Docket Number:	19-BSTD-01
Project Title:	2019 Alternative Calculation Method Reference Manuals and Compliance Software Tools
TN #:	234380
Document Title:	California Energy Commission Comments - NAPHN Comment Letter
Description:	N/A
Filer:	System
Organization:	California Energy Commission
Submitter Role:	Public
Submission Date:	8/19/2020 10:33:32 PM
Docketed Date:	8/20/2020

NAPHN Comment Letter

Re: “HRV White Paper on Revisions to HRV Standard Designs and Modeling: CBECC-Com and CBECC-Res 2019.2.0” A proposal to derate the credits assigned to HRV’s.

Image source: PHCA's website article - CASE Passive House Low-rise Multifamily Reach Code Delivers Results!

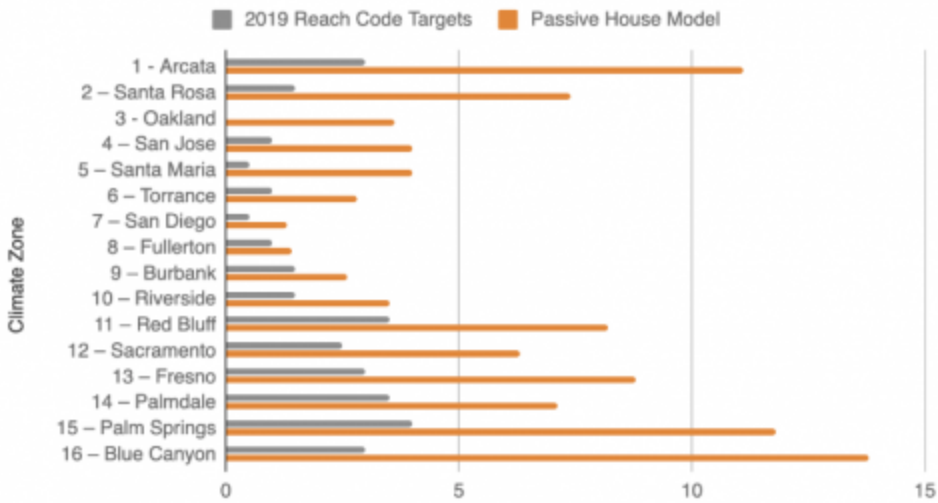
As part to the 2019 Low-Rise Multifamily Reach Code proposal reviewed and vetted by Codes and Standards earlier this year, Passive House California (PHCA) confirmed that low-rise multifamily buildings designed and built with HRV’s with measured efficiency capture above 75% would far exceed the EDR margins currently required for 2019 Reach Code targets. We found that while not all climates in California require the heating/cooling energy recovery, they all benefit from their use. *This offers surprising cost-effectiveness opportunities to developers once they discover that heating equipment may be eliminated in particular climates.*

Image 2: Comparative testing results for three HRV's showing HVI results (in red) compared to DIN V 18599-6:2007-02 and DIN EN 13141-7:2004(D) testing protocol results. Info source: Mr. Eberhard Paul, ZehnderPaul.

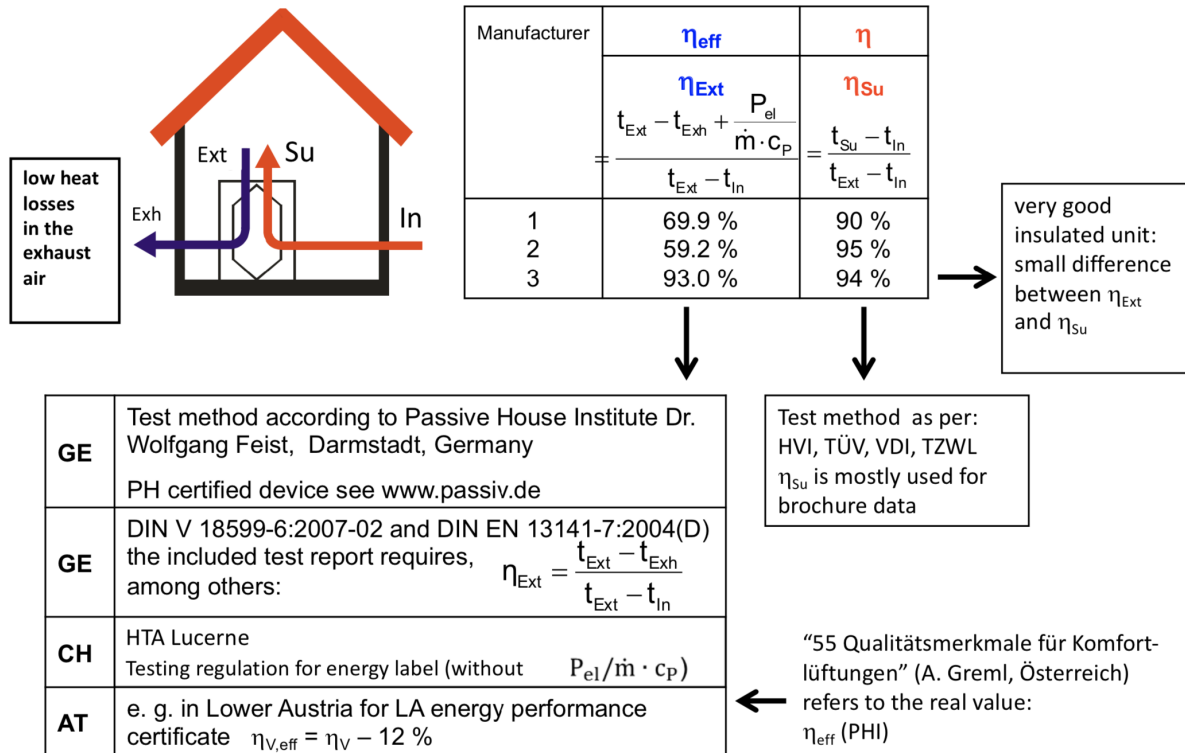
While we support and appreciate the valuable service that the Home Ventilation Institute (HVI) has provided to the industry as the need for, and accurate assessment of mechanical ventilation has grown, we humbly submit that their testing methodology could and should be updated. A deviation in how effective recovery of HRV's is measured exists between HVI's testing protocol and that used by a number of HRV testing protocols commonly used in Europe, including that used by the Passive House Institute. The difference hinges upon which location in the ventilator that the heat recovery is measured: HVI measures this at the outflow, while the other commonly accepted protocols (including that used by the Passive House Institute) measure at the point of extraction.

The graphic included below shows results for three separate HRV units from different manufacturers when tested using the two protocols. The η_{Ext} results vary significantly for the less effective units, compared to the η_{Su} results for the same units.

Image 3: Comparative testing results for moderately efficient HRV's showing HVI results (in red) compared to DIN V 18599-6:2007-02 and DIN EN 13141-7:2004(D) testing protocol results. Info source: Mr. Eberhard Paul, ZehnderPaul.

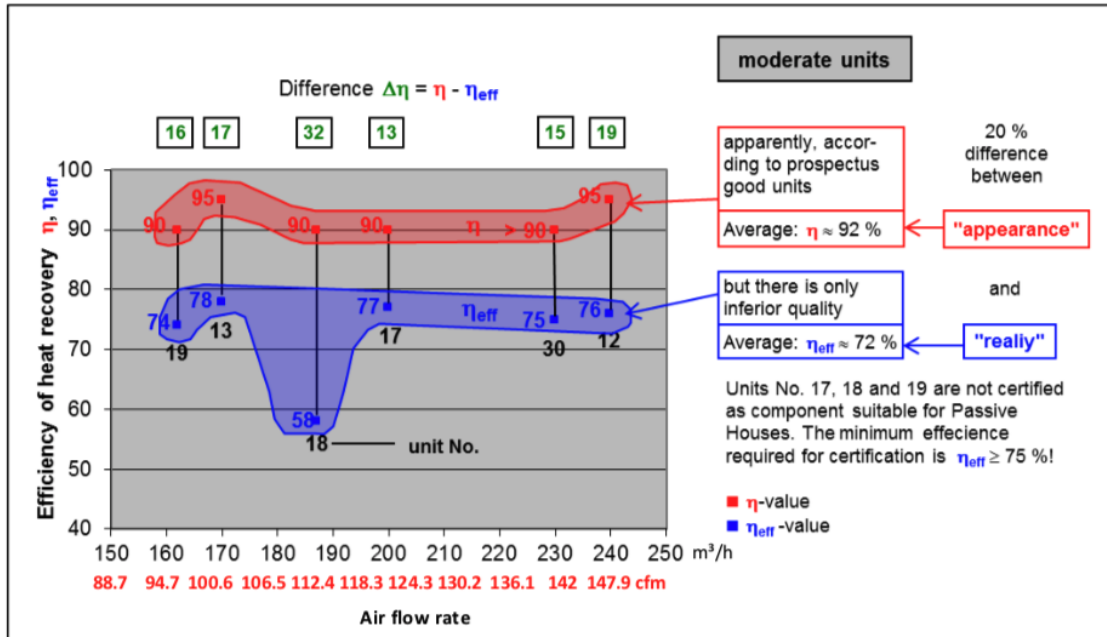
In a series of tests run by the staff at Zehnder/Paul, Germany, on a larger number of HRV's, the inconsistency of results using the two protocols was further confirmed. A deviation in results was found to be particularly pronounced for moderately efficient units.

Image 4: Comparative testing results for highly efficient HRV's showing better alignment in HVI results (in red) when compared to DIN V 18599-6:2007-02 and DIN EN 13141-7:2004(D) testing protocol results.
Info source: Mr. Eberhard Paul, ZehnderPaul.

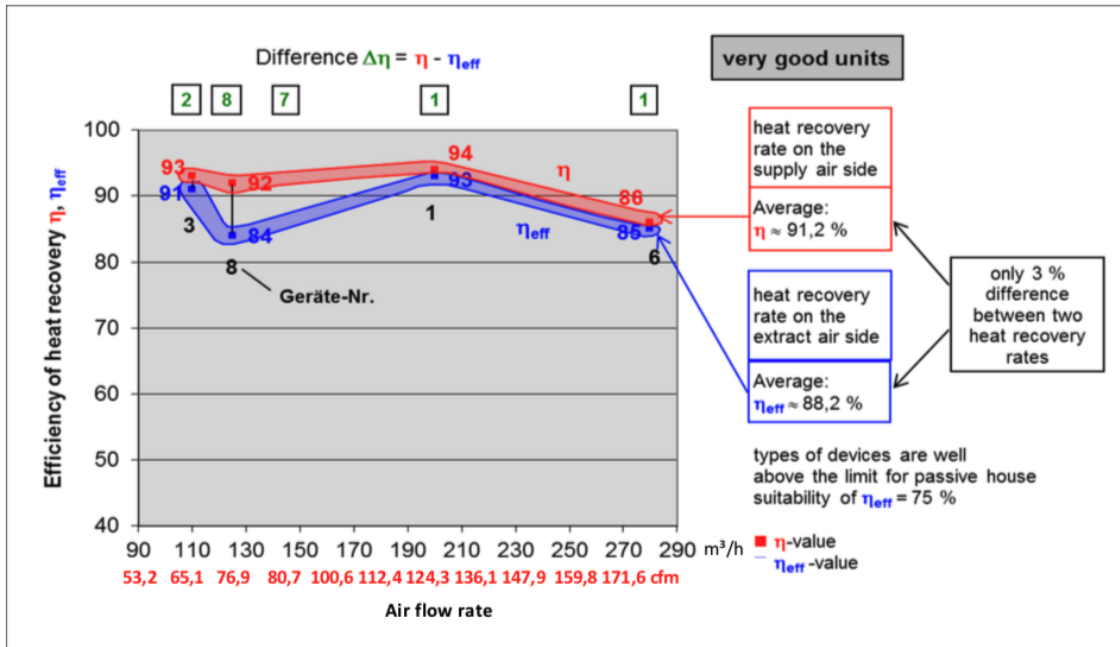
When units rated with much higher effective capture efficiency were tested, results became more aligned in both protocols. These results support our proposal above to **consider providing higher credit points for units with effective recovery efficiencies above 80%, and underscore our motivation to modify HVI testing protocols, or accept alternate testing protocols for E/ERV's.**
